**TNMP – Silverleaf and Cowpen 345/138-kV  
Stations Project ERCOT Independent  
Review Status Update**

RPG Meeting  
Sep 19, 2023

# Project Need (P0, P1, P2-1, P3, P6-2, and P7) as Seen by ERCOT

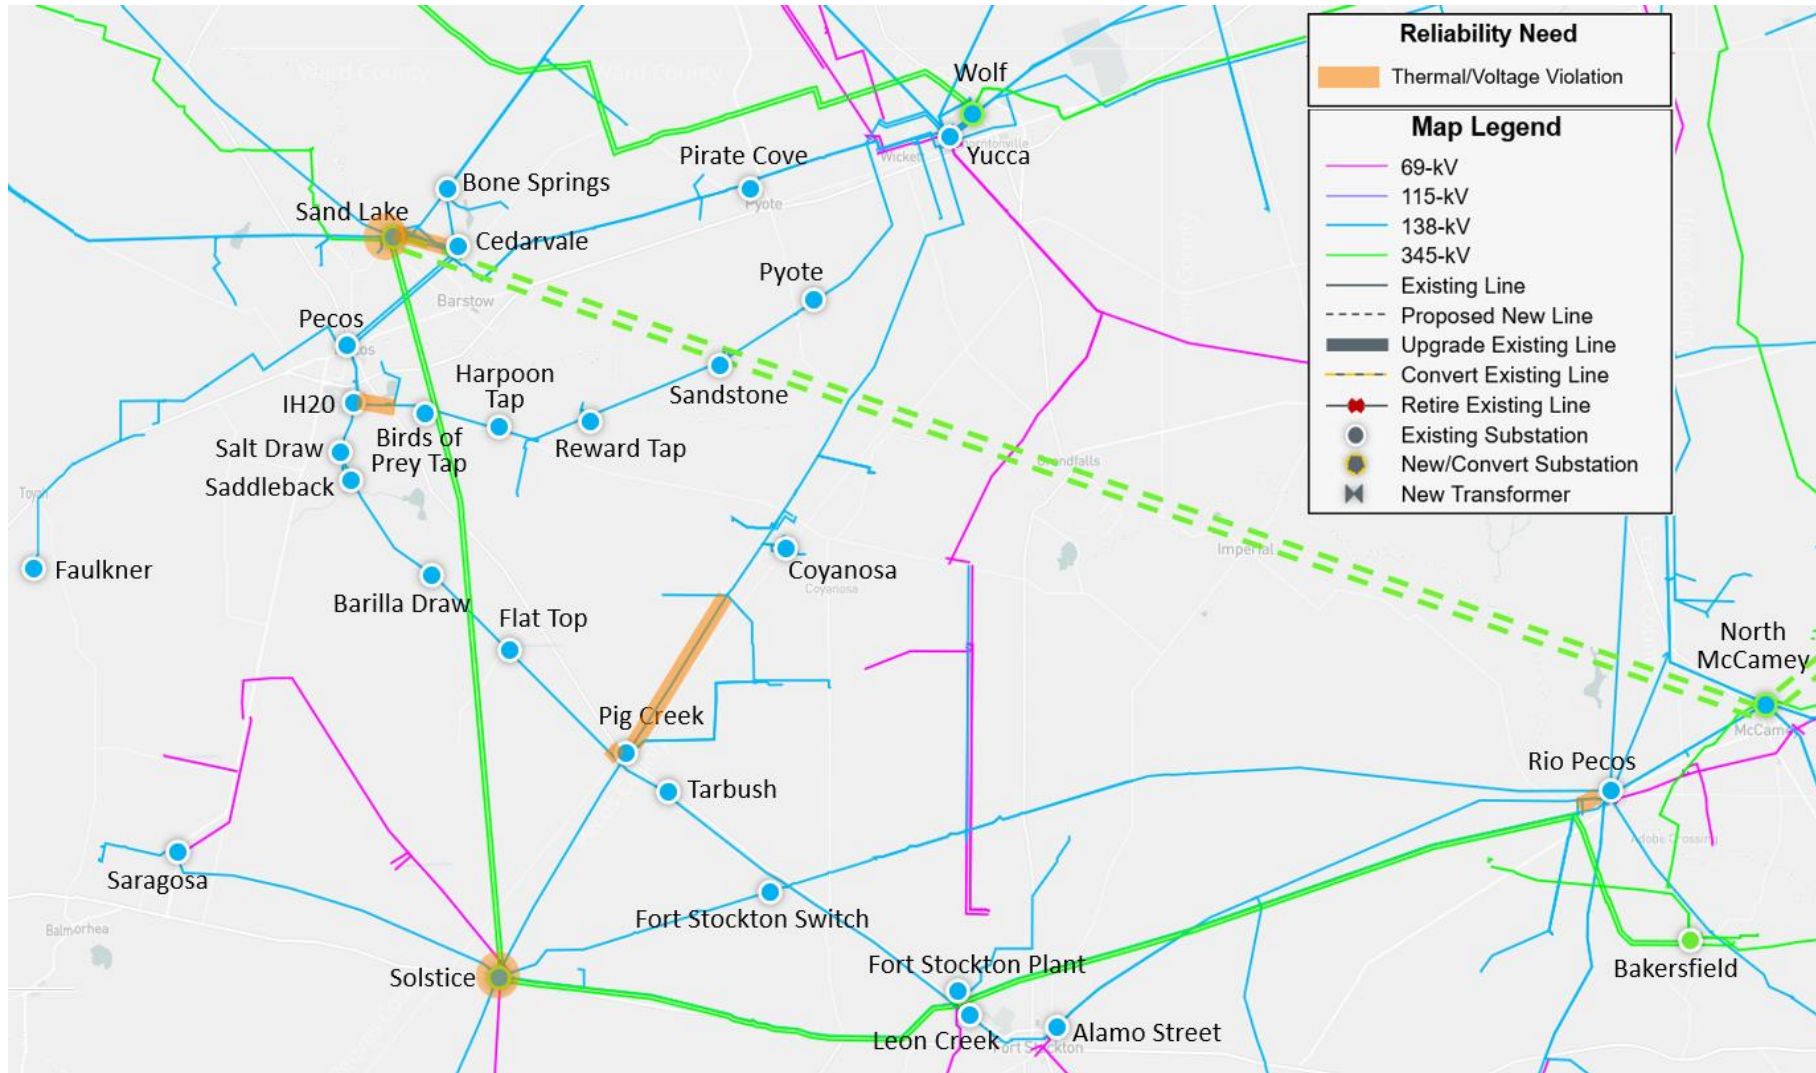
- ERCOT conducted steady-state load flow analysis for the study base case according to the NERC TPL-001-5.1 and ERCOT Planning Criteria

Contingency Category	Thermal Overloads	# of Unsolved Contingencies
N-0 (P0)	Two 345/138-kV transformers, 2 circuit miles of 138-kV line	0
N-1 (P1, P2-1, P7)	16.1 circuit miles of 138-kV line	3
G-1+N-1 (P3)	2.5 circuit miles of 138-kV line	2
X-1+N-1 (P6-2)	Three 345/138-kV transformers, 5 circuit miles of 138-kV line	
Total	Five 345/138-kV transformers, 25.6 circuit miles of 138-kV line	5

# Upgrades Included for All Options

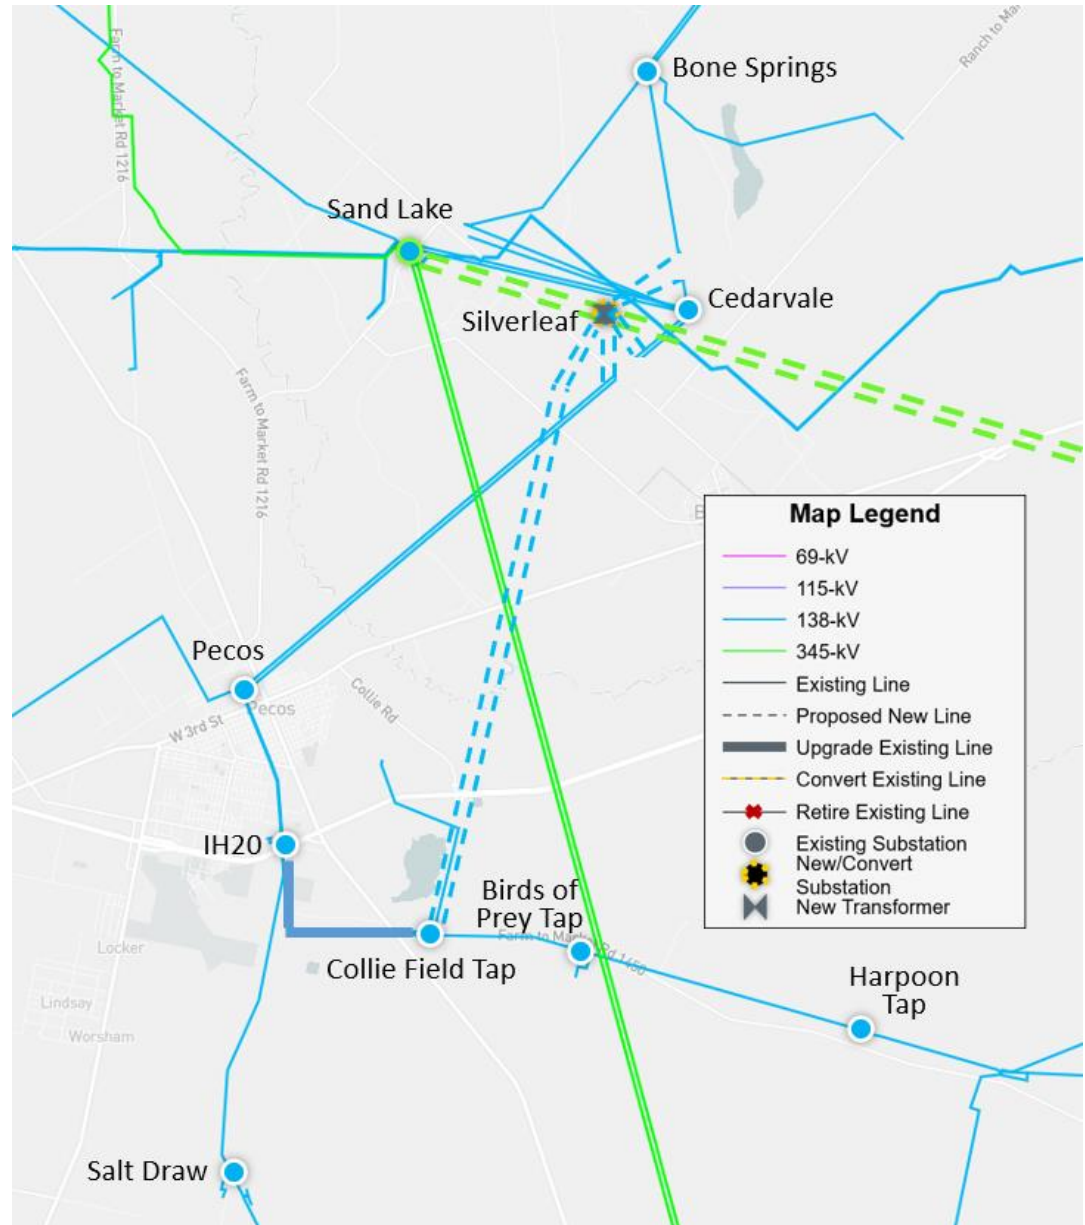
- Reactive Support
  - Add capacitor banks (total 160 Mvar) at Coyanosa (38380) 138-kV substation
- Transmission Upgrades
  - Upgrade the existing Rio Pecos to Girvin 138-kV circuit 2 (~ 0.53 miles) to 717 MVA
  - Upgrade the existing Pig Creek to Foxtail 138-kV double circuits (~ 0.2 miles) to 717 MVA (A new Tier 4 TPIT # 76348 with the expected in-service date of Summer 2026)

# Option 3

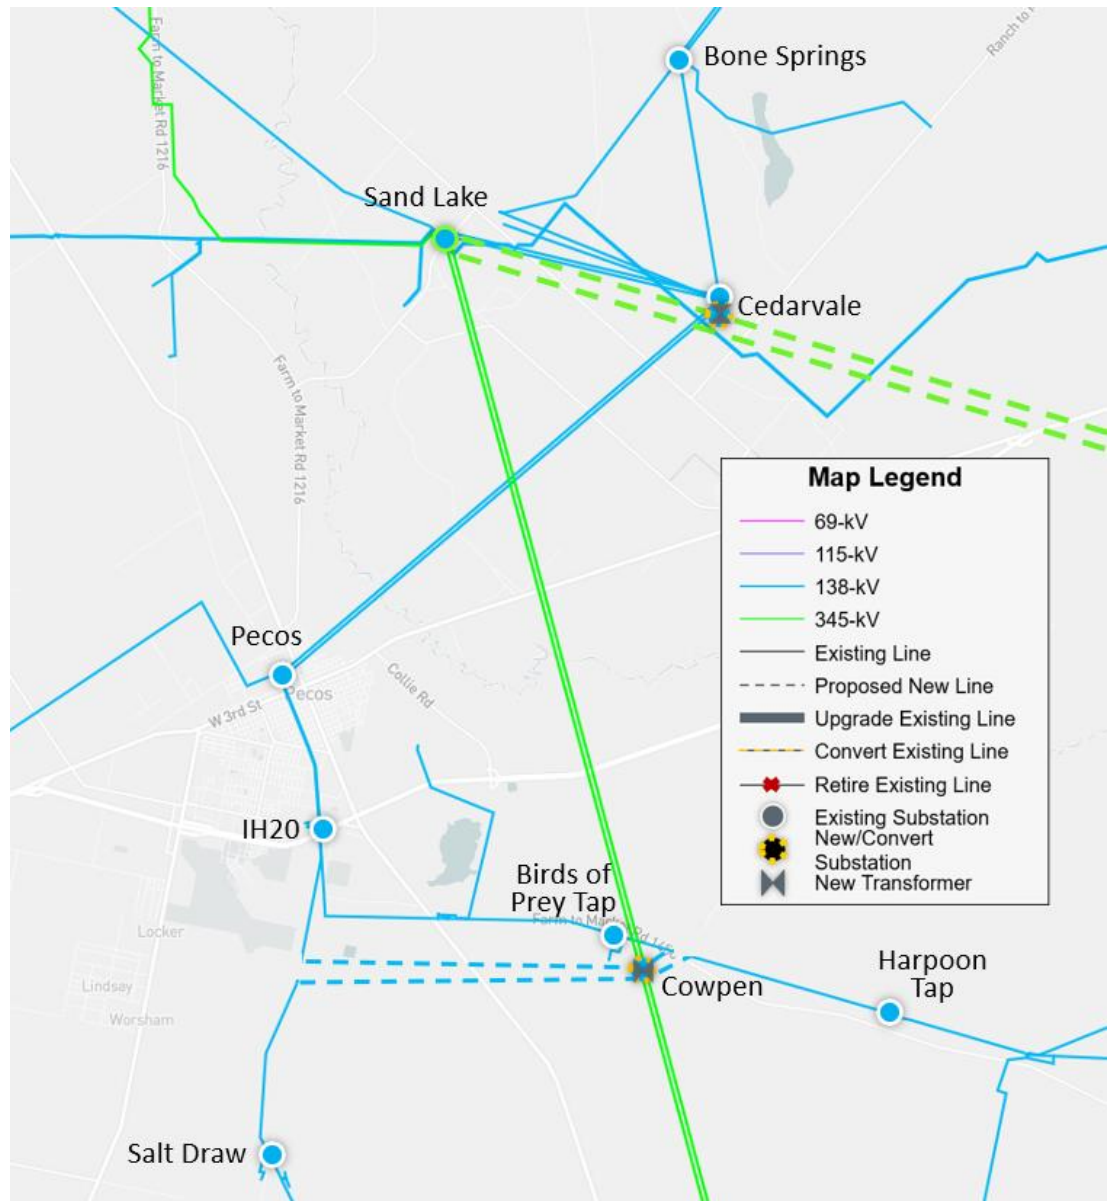
- Expand the existing Cedarvale 138-kV station to 345/138-kV with three transformers
- Loop the planned North McCamey – Sand Lake 345-kV double-circuit line into the Cedarvale 345/138-kV station
- Add a new 345-kV New Substation 2, ~ 13 miles away from the existing Sand Lake station, by cutting into the existing Sand Lake – Solstice 345-kV double-circuit line
- Add a new 345/138-kV Cowpen station, nearby New Substation 2, with two transformers, connecting to the nearby New Substation 2 via two 345-kV tie lines
- Loop the existing IH20 – Salt Draw 138-kV line and Birds of Prey Tap – Harpoon Tap 138-kV line into the new Cowpen station

# Option 4

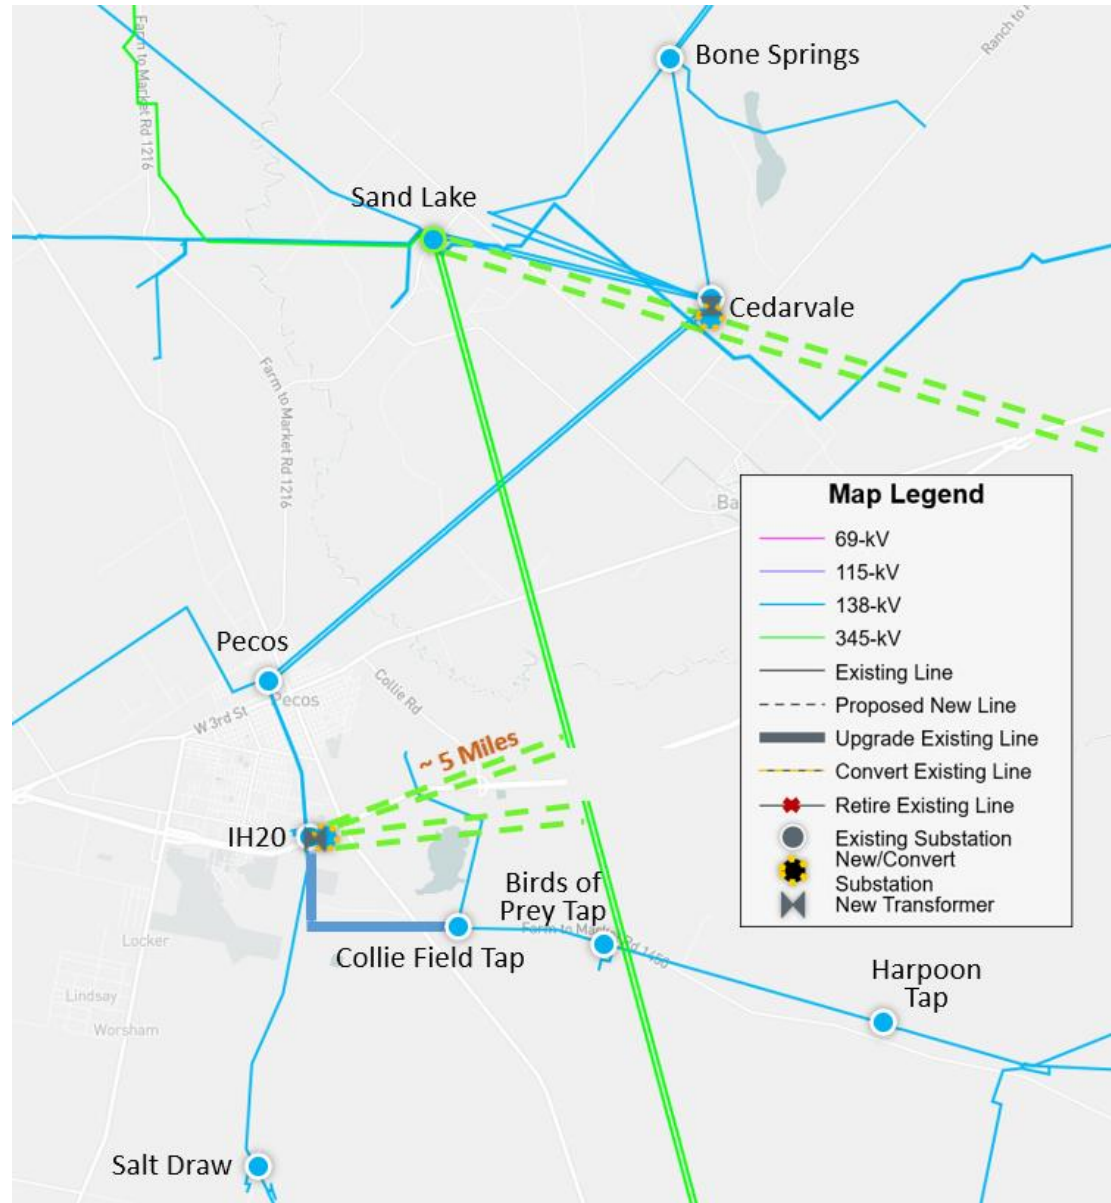
- Expand the existing Cedarvale 138-kV station to 345/138-kV with three transformers
- Loop the planned North McCamey – Sand Lake 345-kV double-circuit line into the Cedarvale 345/138-kV station
- Expand the existing IH20 138-kV station to 345/138-kV with two transformers
- Loop the existing Sand Lake – Solstice 345-kV double-circuit line into the IH20 345/138-kV station
- Upgrade the existing IH20 – Collie Field Tap 138-kV line (2.95 miles)
